Revisions: 27.04.23 RESPONSE TO RFI KW

Project: **BALFOUR PLACE**

Drawing: **BASEMENT COMPARATIVE PLANS**

Drawing No: **RFI - 01**

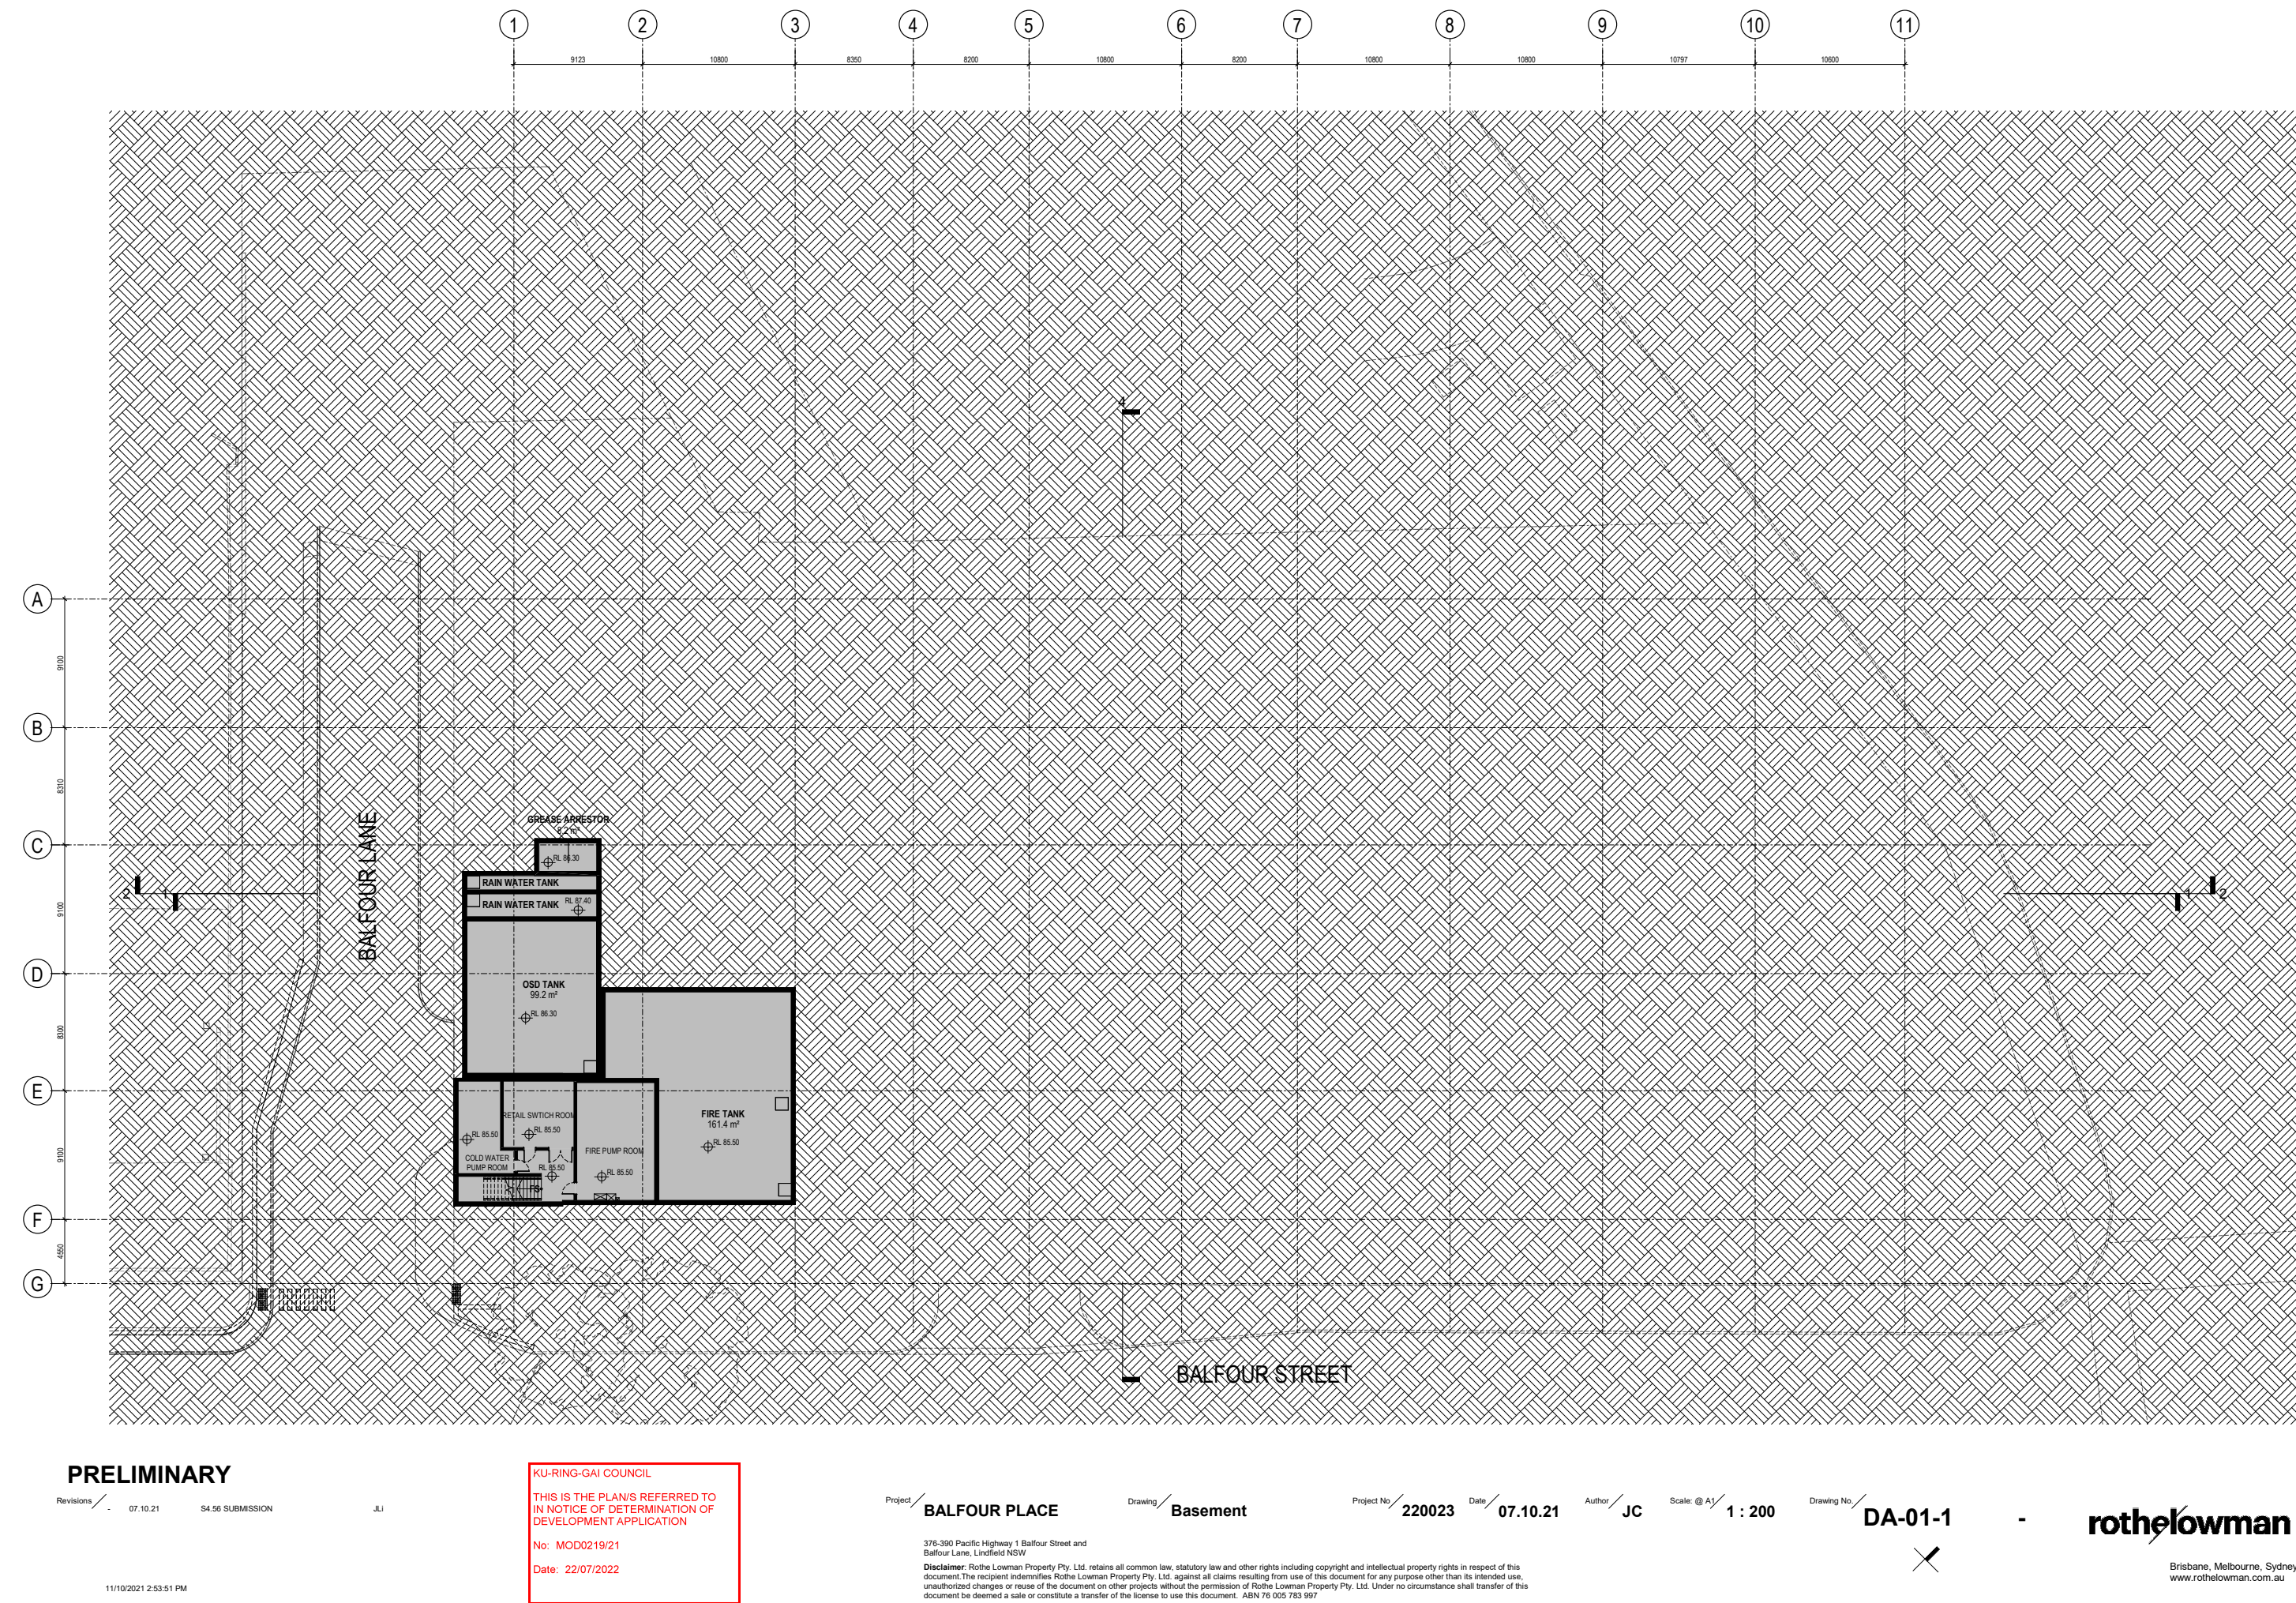
1. FIRE TANK RECONFIGURED

Drawing: **LOWER GROUND 2
COMPARATIVE PLANS**

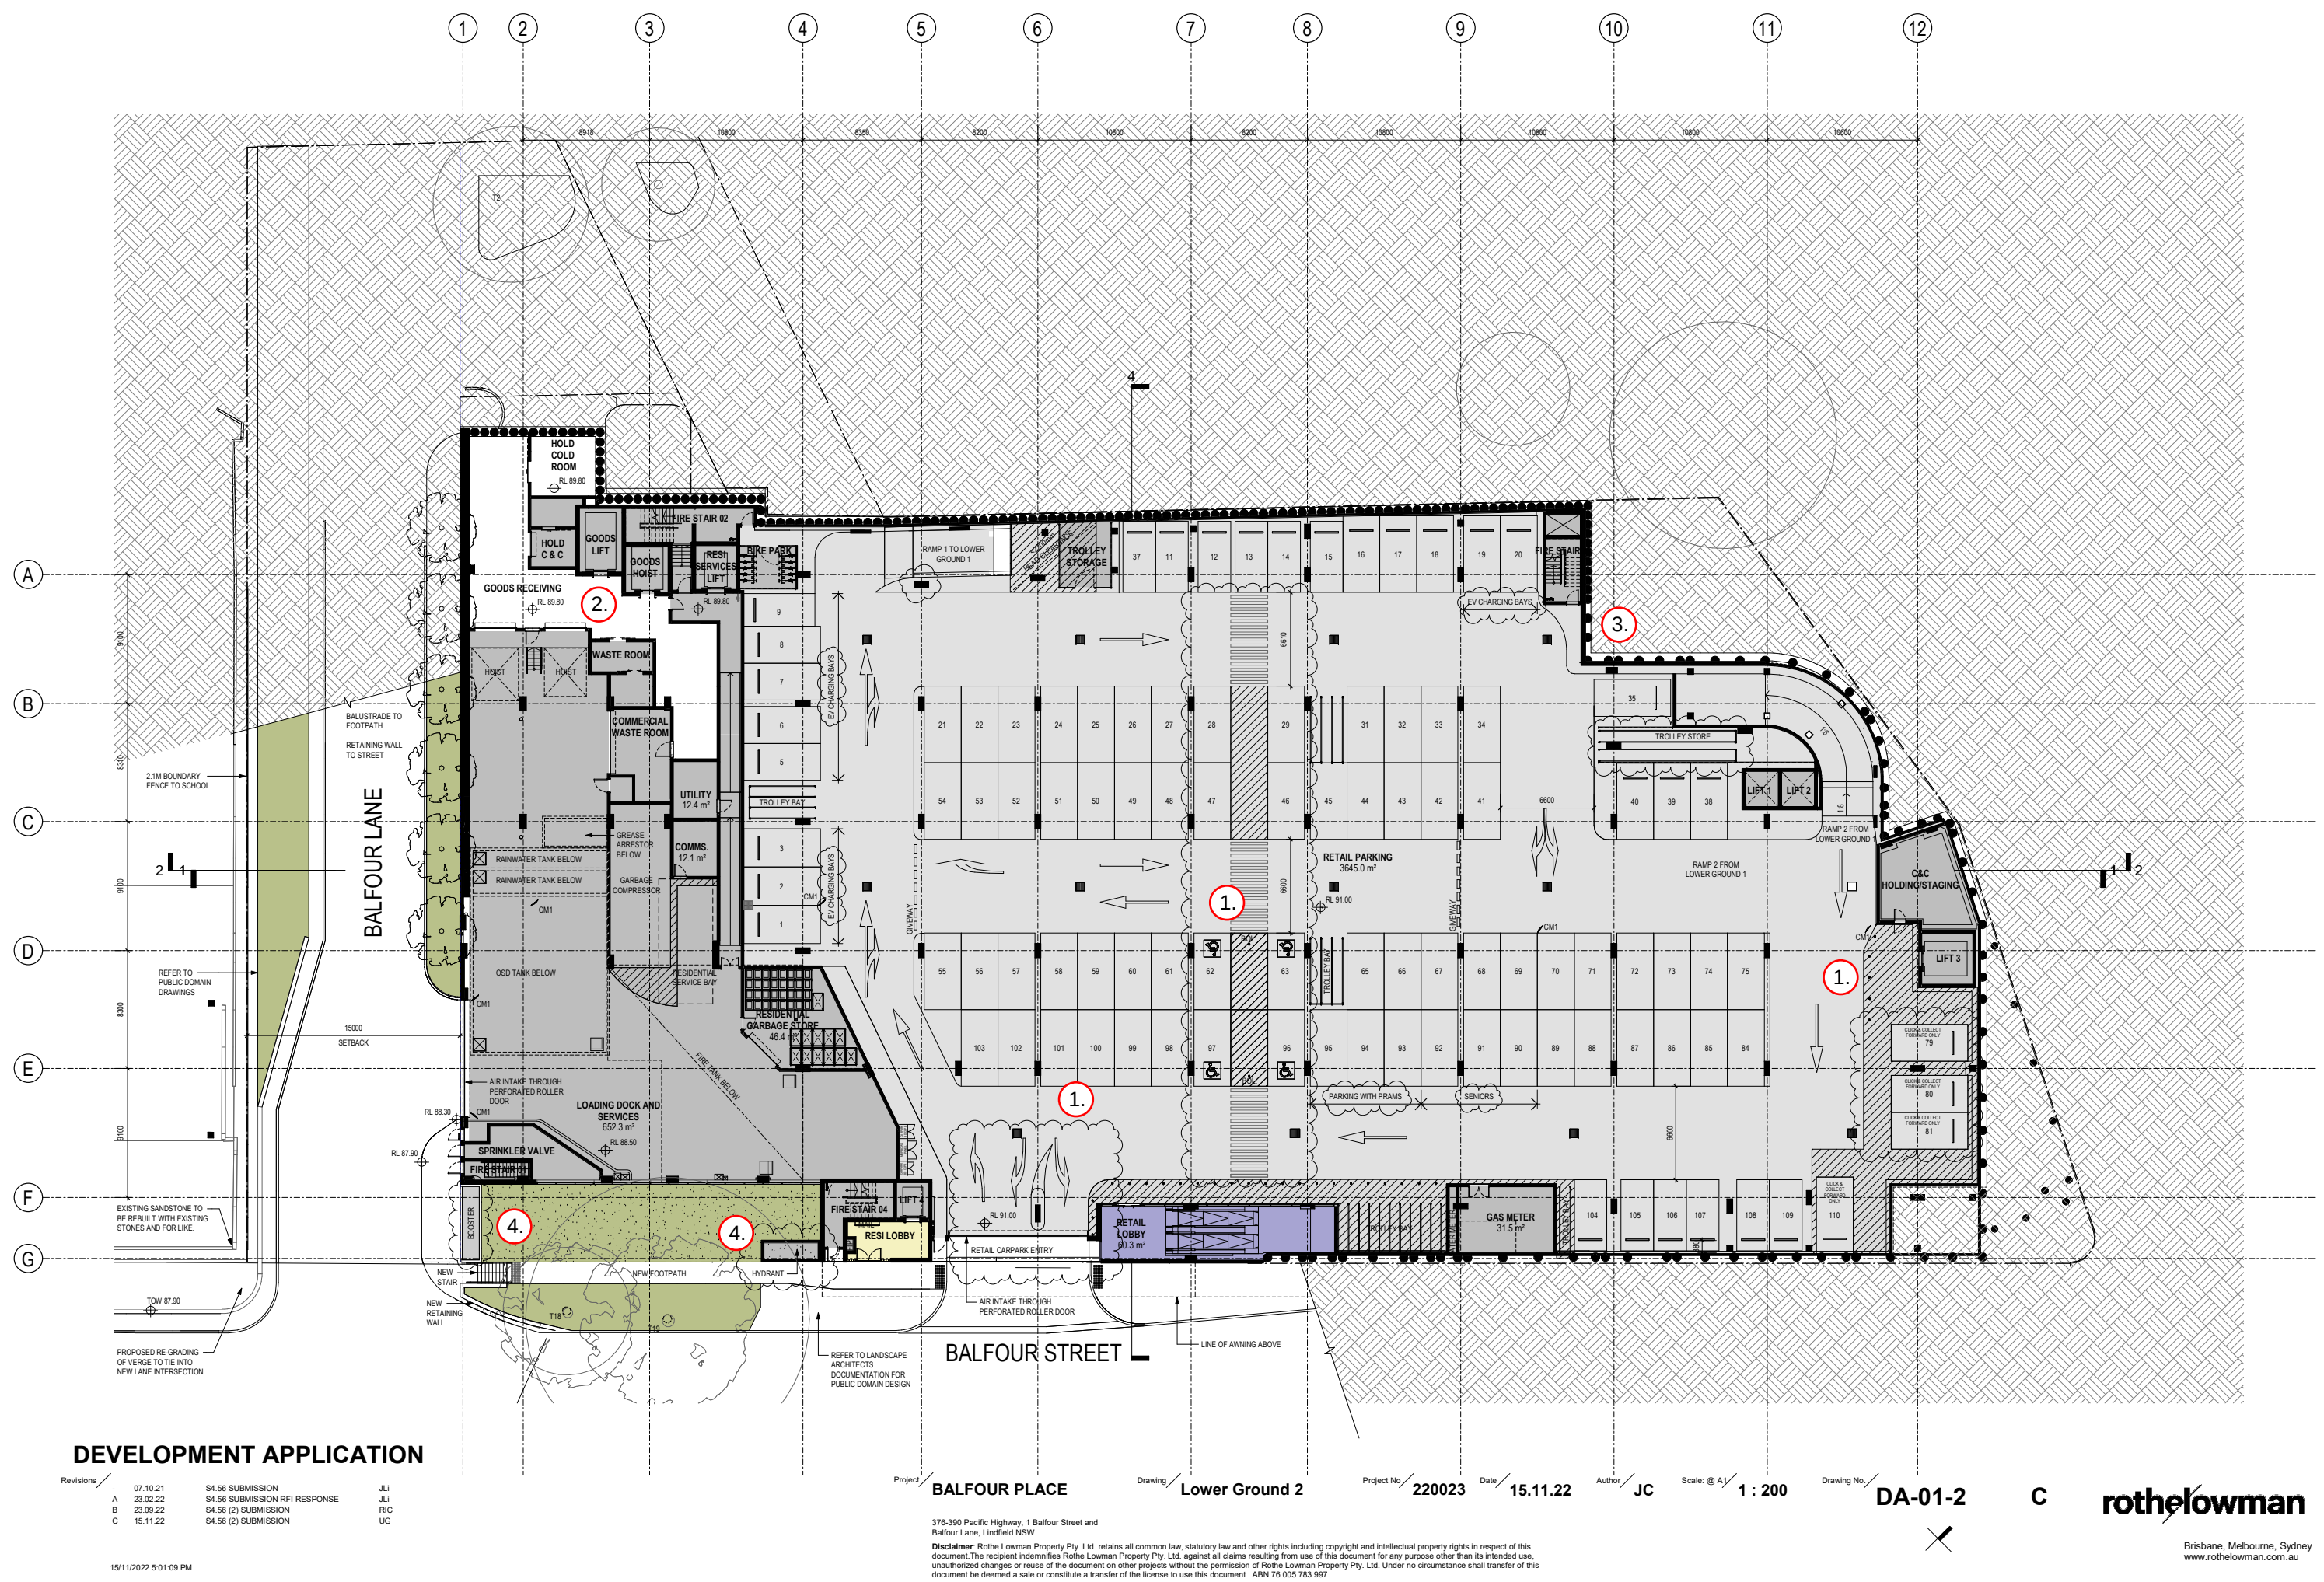
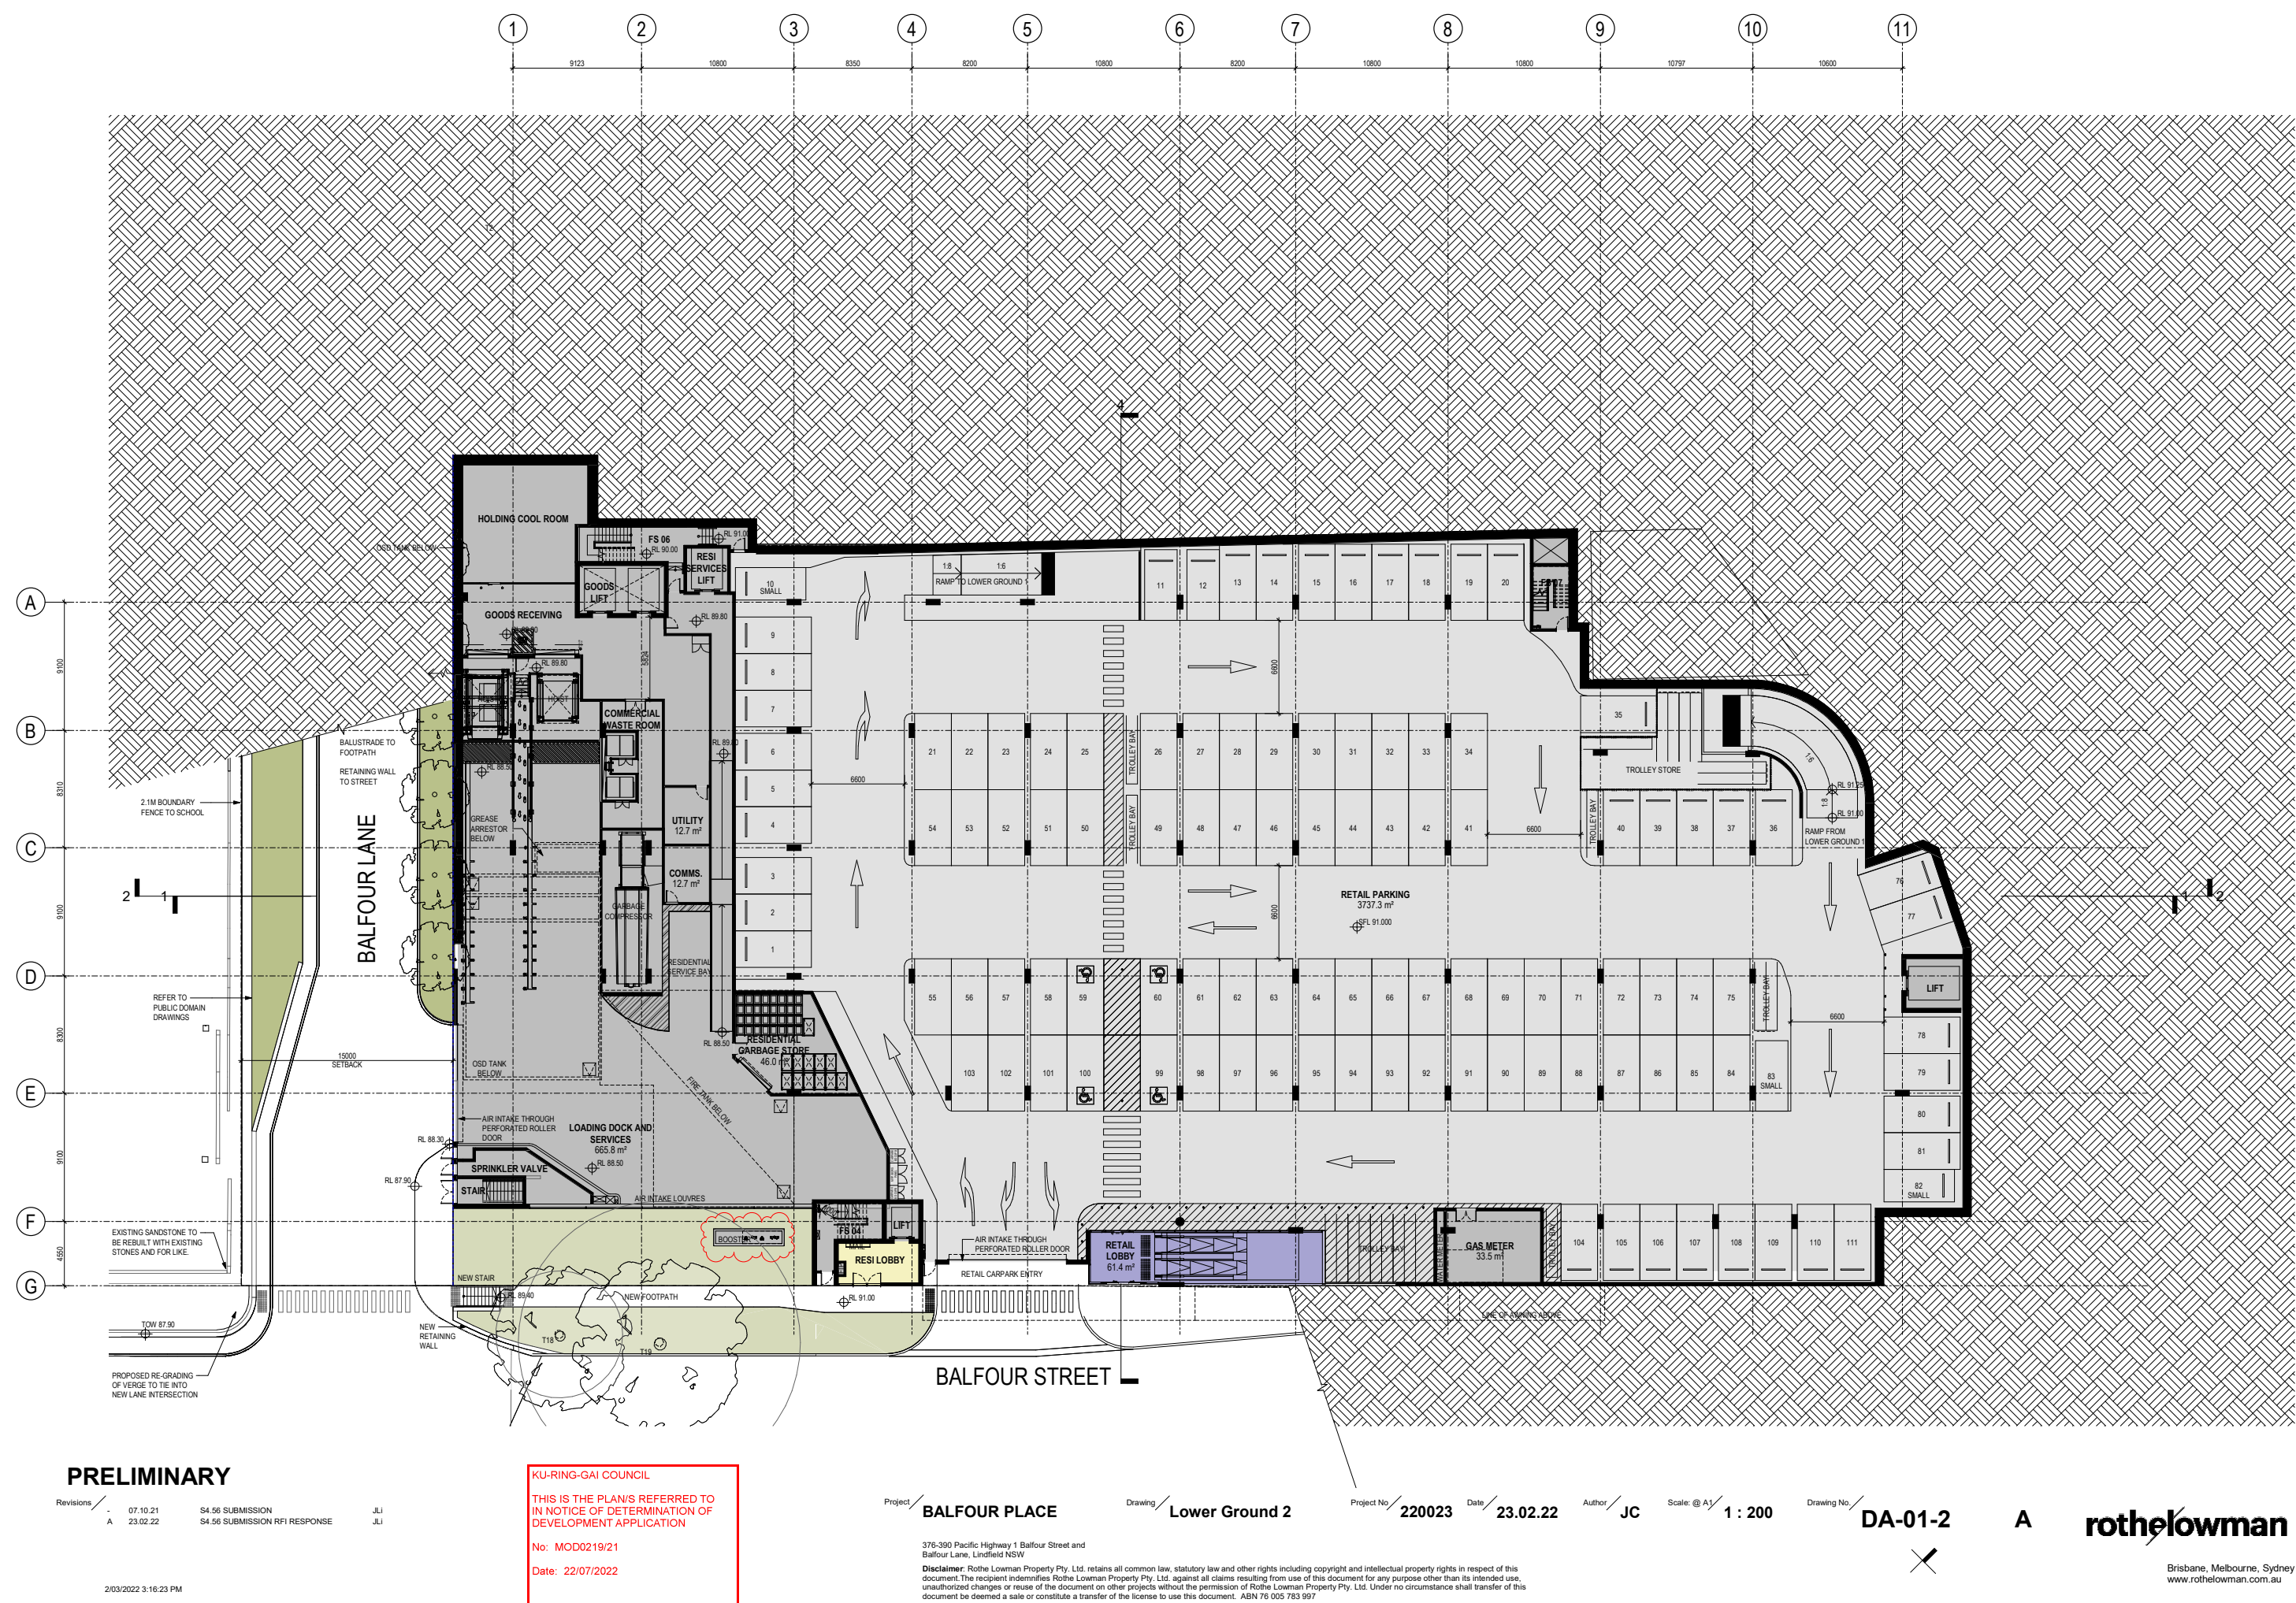
1. RETAIL CARPARK LAYOUT CHANGES - REDUCTION IN CARS (CLICK AND COLLECT, TROLLEY BAYS)
2. COLES GOODS LIFTS AND ASSOCIATED FIRE STAIR LAYOUT UPDATED
3. RATIONALISE SHORING
4. BOOSTER RELOCATION
